NORTHERN STATES POWER COMPANY
PRAIRIE ISLAND NUCLEAR GENERATING PLANT

REQUEST FOR AMENDMENT TO
OPERATING LICENSE NOS. DPR-42 & DPR-60

(License Amendment Request Dated July 11, 1984)

Evaluation of Proposed Changes to the Technical Specifications
Appendix A of Operating Licenses DPR-42 and 60

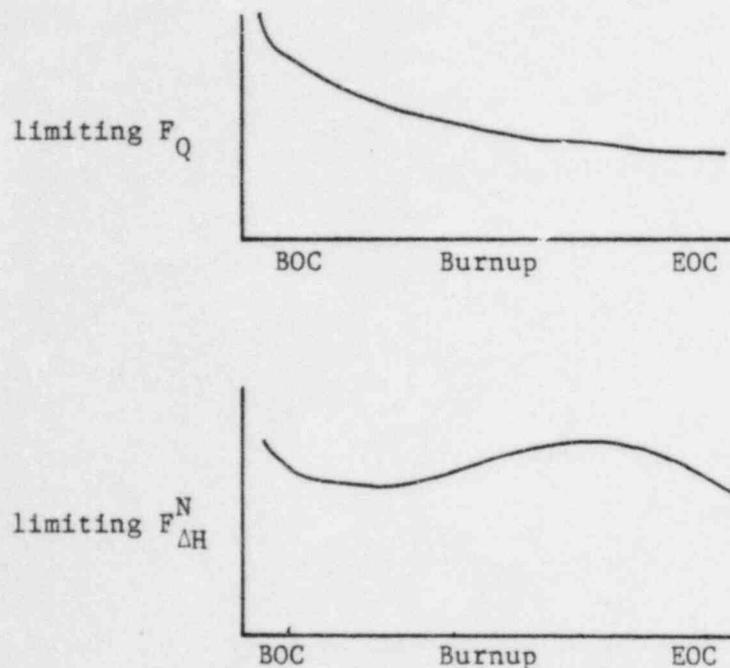
The changes discussed here are associated with new peaking factor limit functions. Rather than have one F_Q and $F_{\Delta H}^N$ limit, two functions are proposed. The F_Q limit could then be lowered within the range of 2.32 to 2.28, gaining $F_{\Delta H}^N$ margin within the range of 1.55 to 1.65.

As shown on the above curve F_Q typically peaks sharply at the beginning of the cycle and generally decreases throughout the cycle. $F_{\Delta H}^N$ will generally increase as Gadolinia burns out in mid-cycle. Therefore, F_Q can be limiting at the beginning of cycle but $F_{\Delta H}^N$ can limit mid-cycle operations. The requested changes will allow flexibility by allowing, for example, a higher F_Q limit at beginning of cycle and a higher $F_{\Delta H}^N$ limit in mid-cycle.

Section 3.10.B.3.(a) is being changed to increase the setpoint reduction from 1% to 5% for $F_{\Delta H}^N$. A 5% reduction in power, instead of 1% as currently exists in the Technical Specification, is necessary to increase the $F_{\Delta H}^N$ limit 1%.
